RE: HPS Transmission Line - Certification # PA 89-25. Wetland Mitigation
Proposal for the Hardee - Lee Segments.

HARDEE POWER STATION
PA 89-25
MITIGATION PROPOSAL INCOMPLETENESS RESPONSE

Soil
Boring
Locations

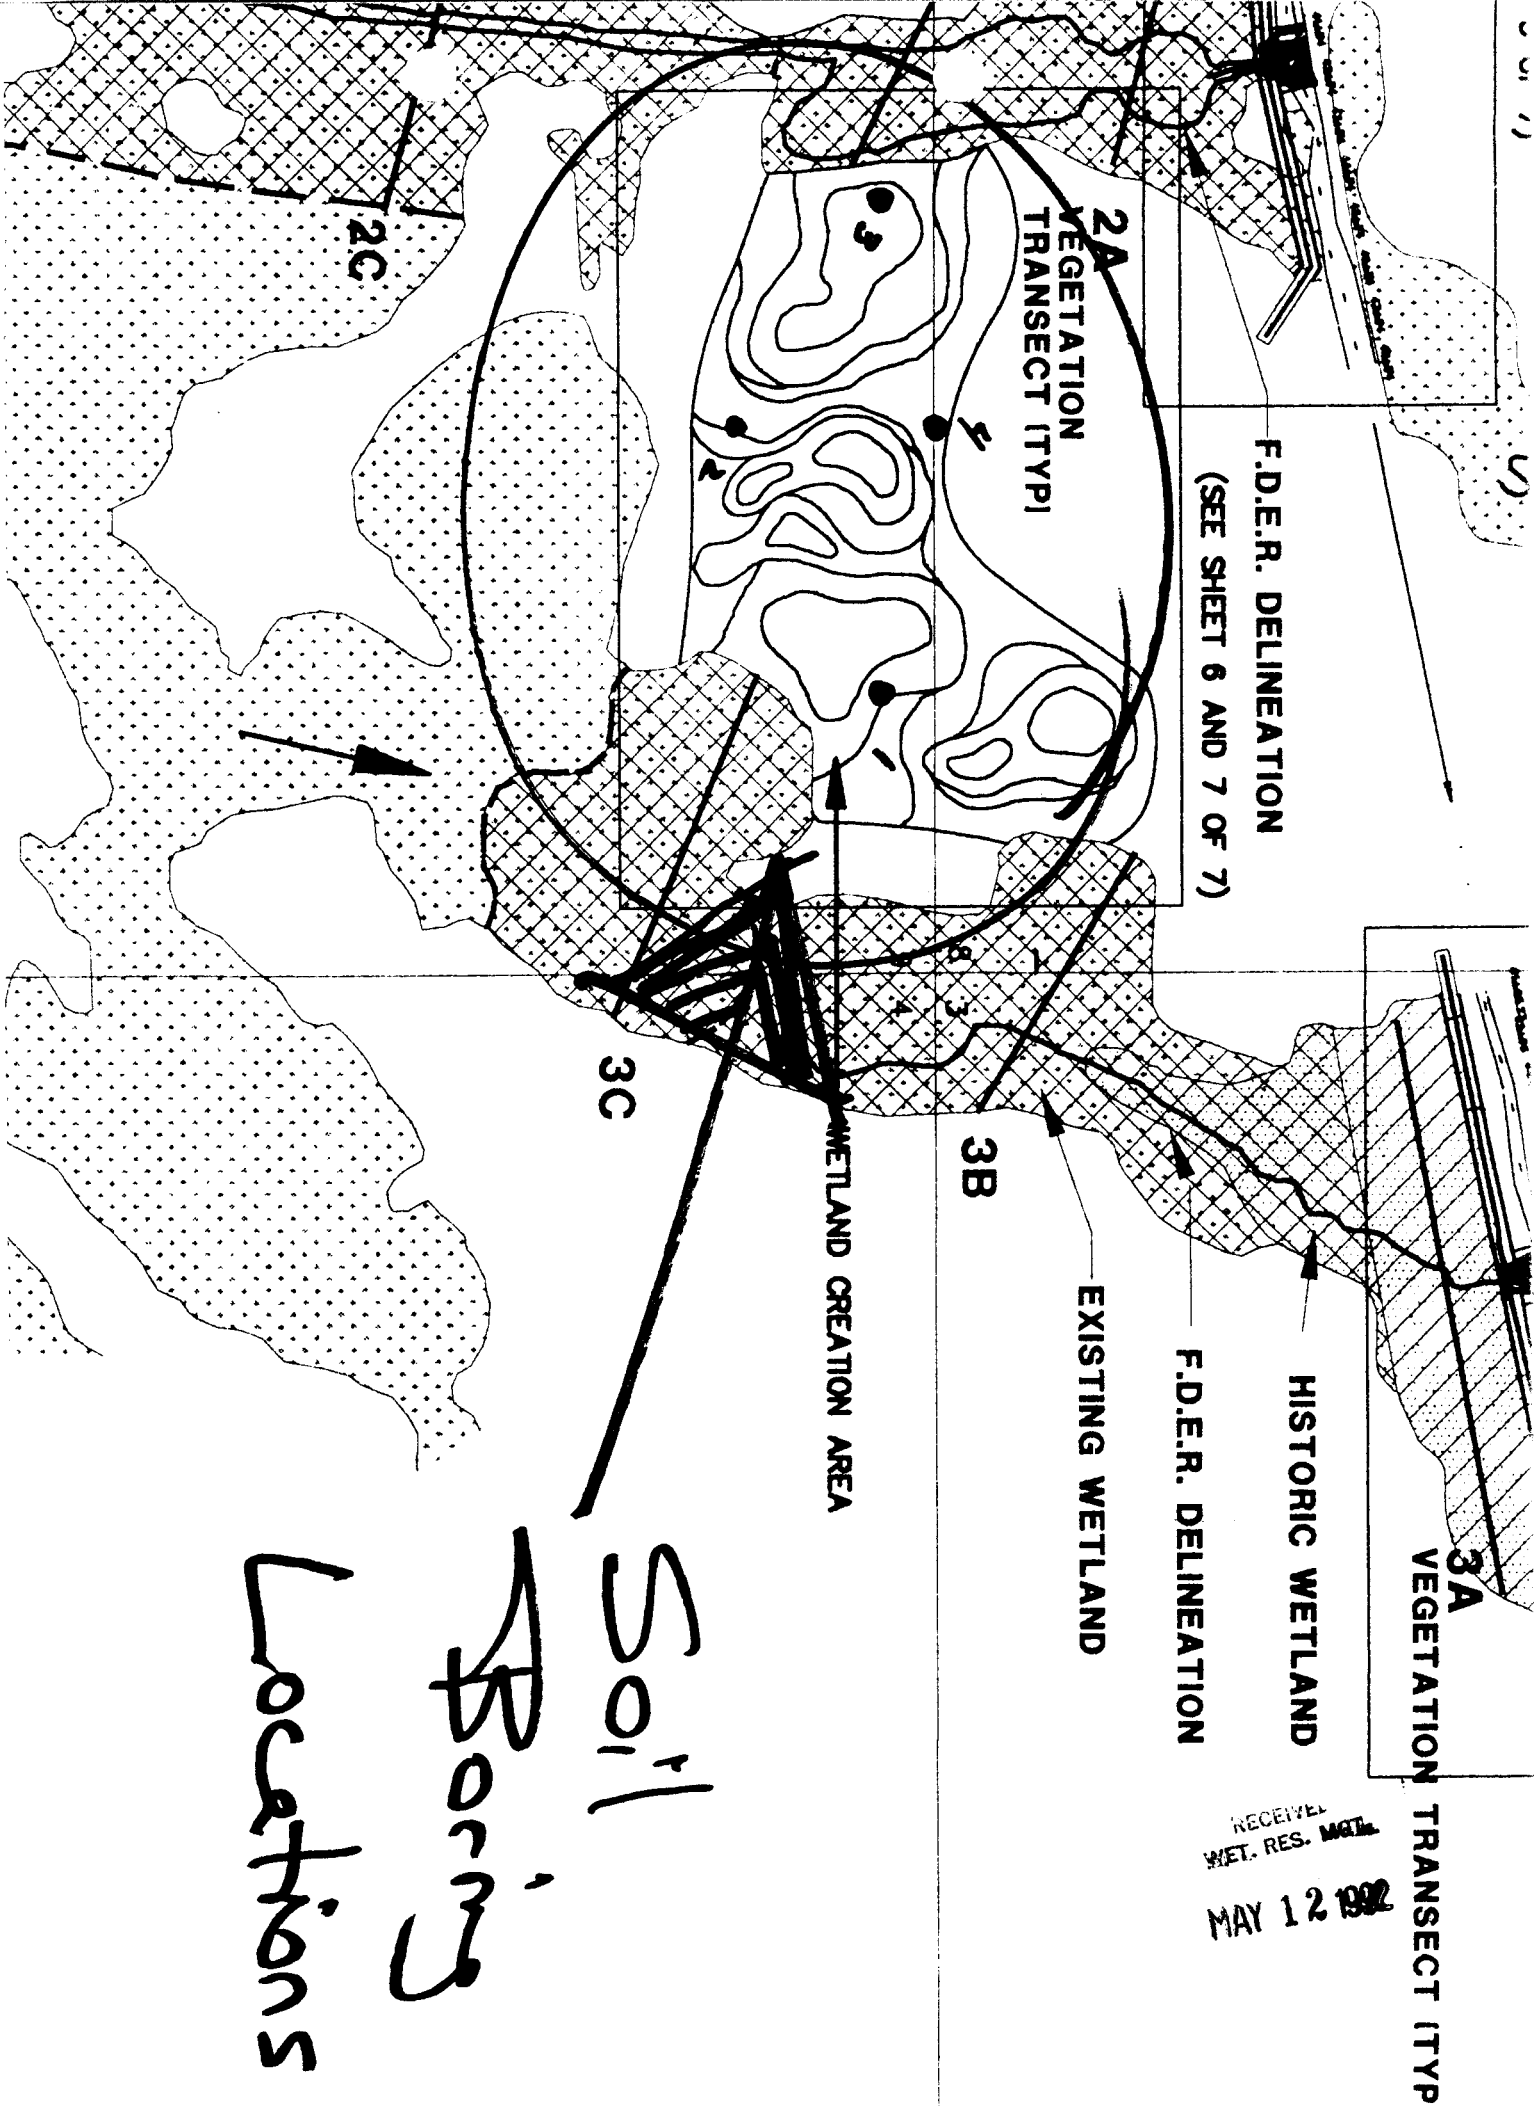
14. Please provide a plan view showing the locations at which the core borings were taken.

Please see the attached drawing.
